The Columbia Architectural Design Review Team will meet on Tuesday, September 12, 2023 at 9:00 AM in Conference Room A on the basement level of City Hall, 700 N. Garden Street to consider the following:

PROJECT DESCRIPTION: Arden Village Retail

PLANNING STAFF EVALUATION:

1 01.00 - 1st floor rv storage shelter area
1" = 40'-0"

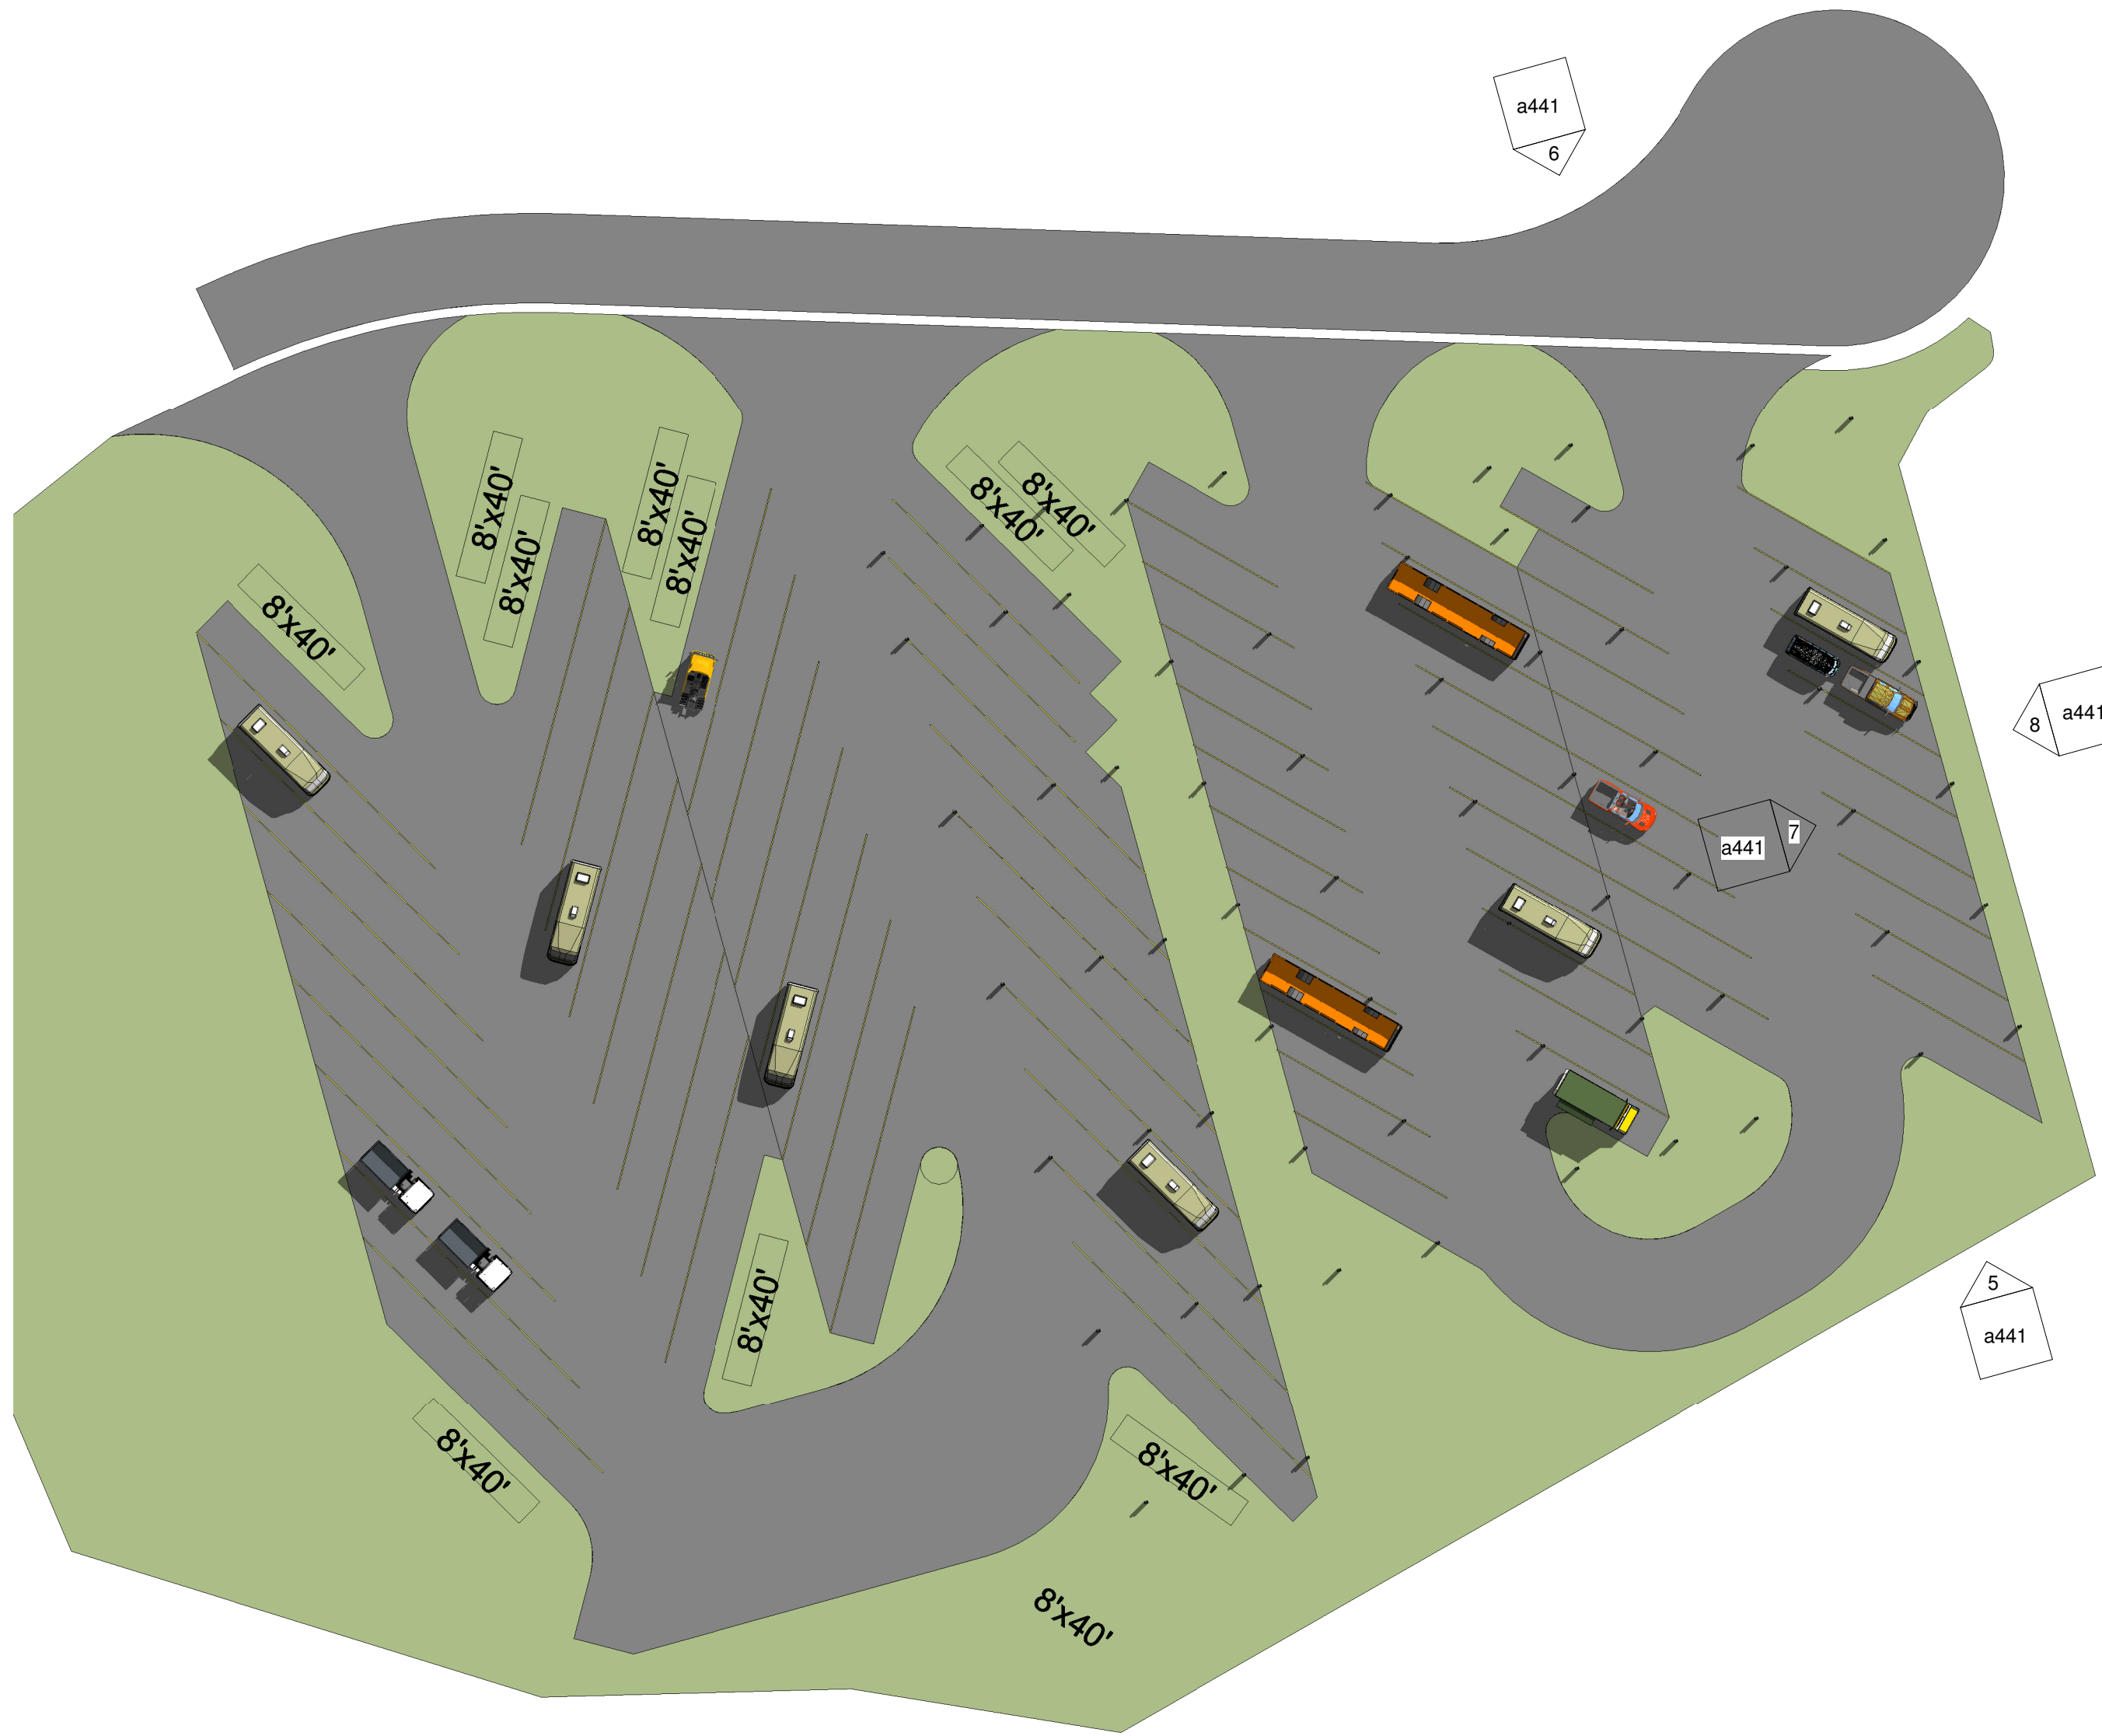
Overall materials will consist of metal cargo containers serving as a non-building component to the site. In addition, RV storage area will consist of a metal roofed structure with metal posts.
